MEETING AGENDA

DATE: Thursday, March 5, 2026

SPRINGFIELD HISTORICAL COMMISSION

THURSDAY, FEBRUARY 19, 2026 / HEARING OVERVIEWS

DRAWN BY
Siervo Jimenez
DESCRIPTION
Front Elevation

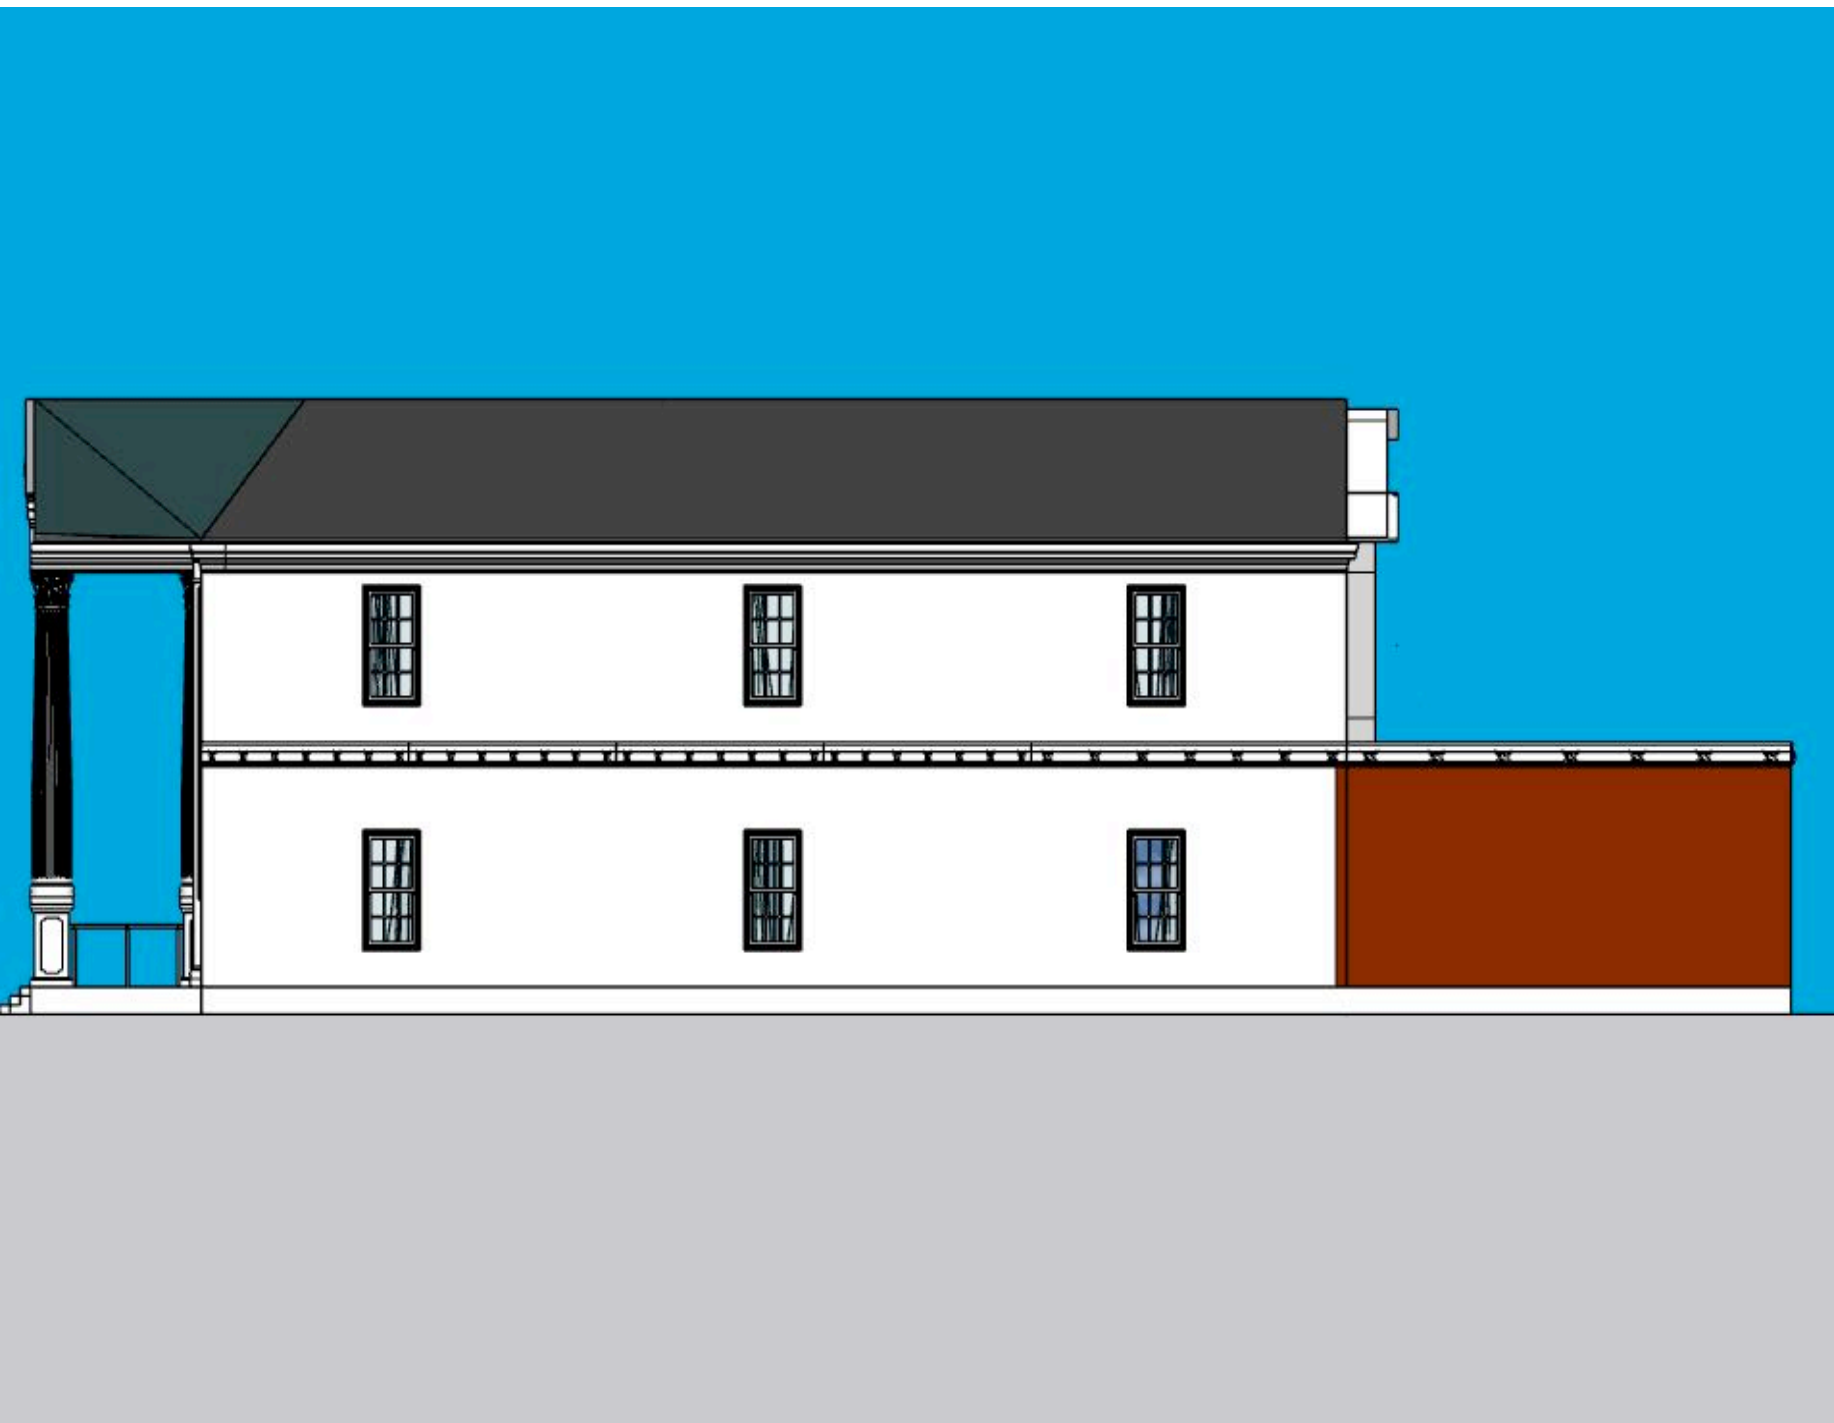
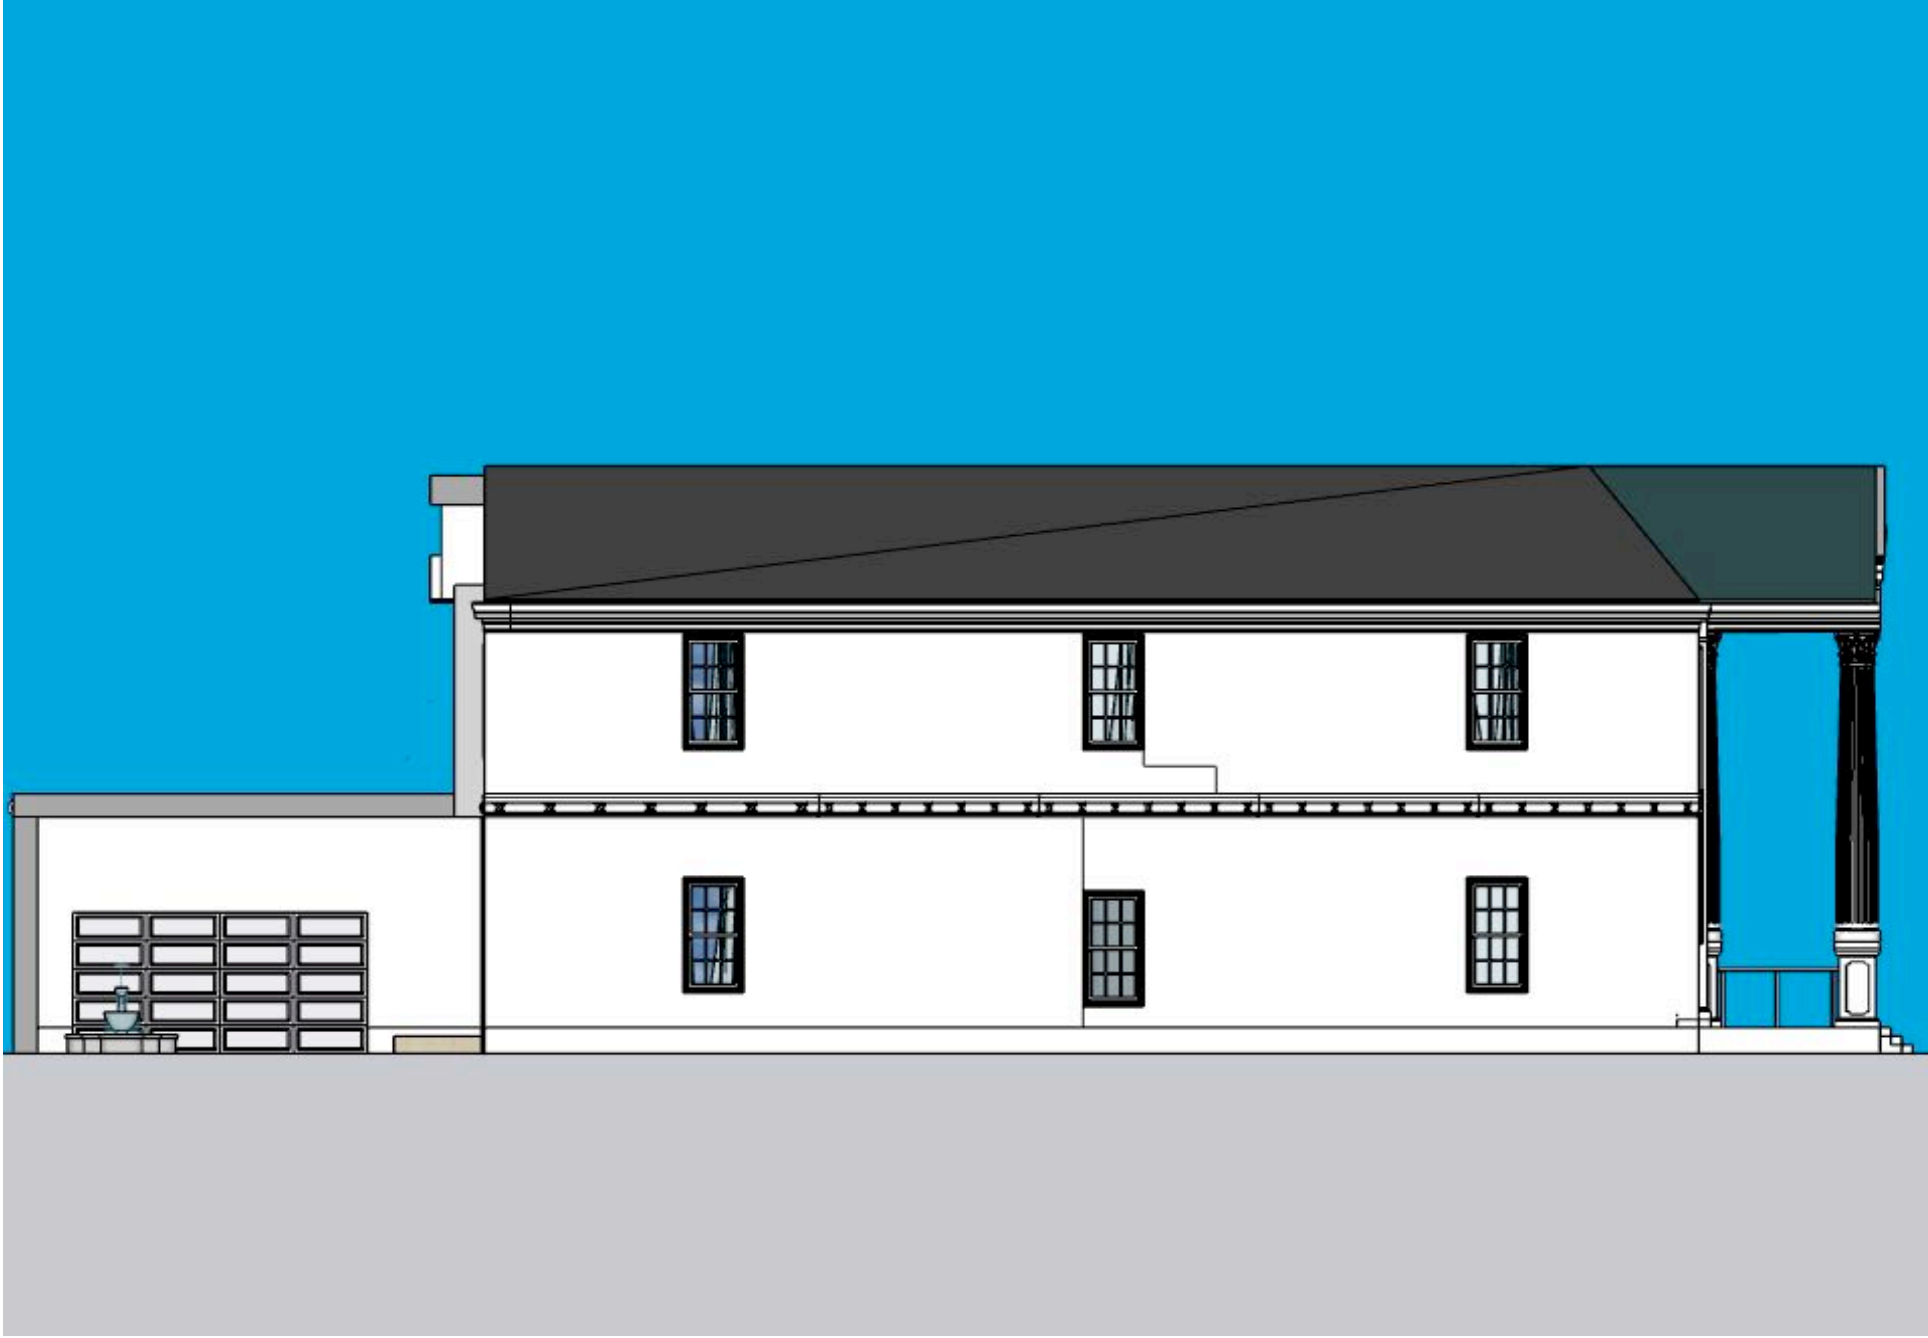
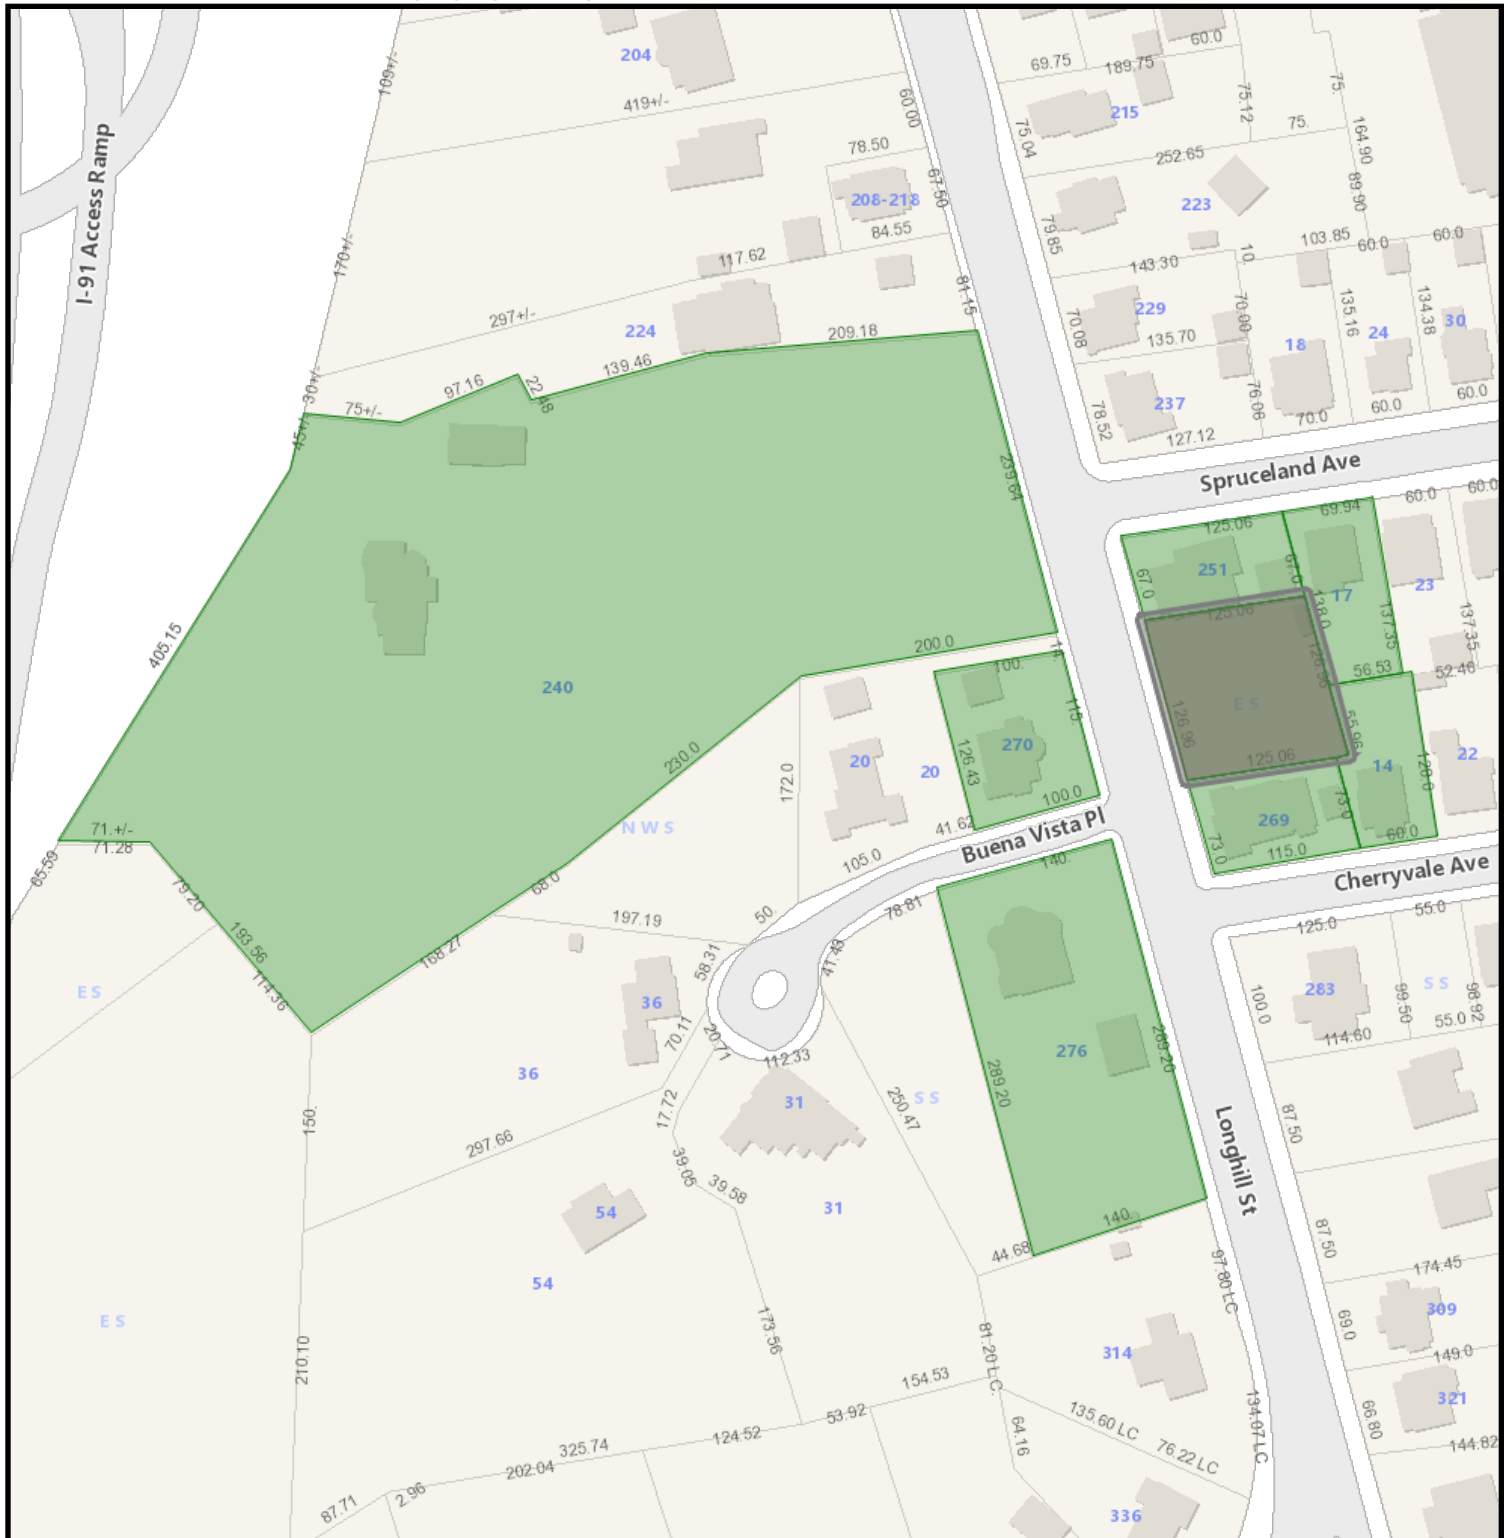
I am writing about the proposal for new construction on the parcel across from my property at 270 Longhill Street. I welcome a house in this location, but said house should be congruous with the rest of the neighborhood. The house proposed has a significant issue - **it is far wider than any other house in the neighborhood.**

The lot in question is drawn as 126 x 125, though the house at 251 Longhill seems to be over the lot line. The proposed house is shown to be 79 feet wide, and 44 feet deep (plus 32 feet deeper for the garage). I have superimposed such a structure on the lot:

The house to the left is about 44 feet wide at the front facade. The house to the right is about 45 feet wide at the front facade. That makes the proposed house **78% wider** than either of those houses. The widest nearby house, at 283 Longhill, is about 66 feet wide. The proposed house is still **20% wider** than that. **The proposed house is simply too wide for the lot**, and at this width, would dominate all other houses to their detriment.
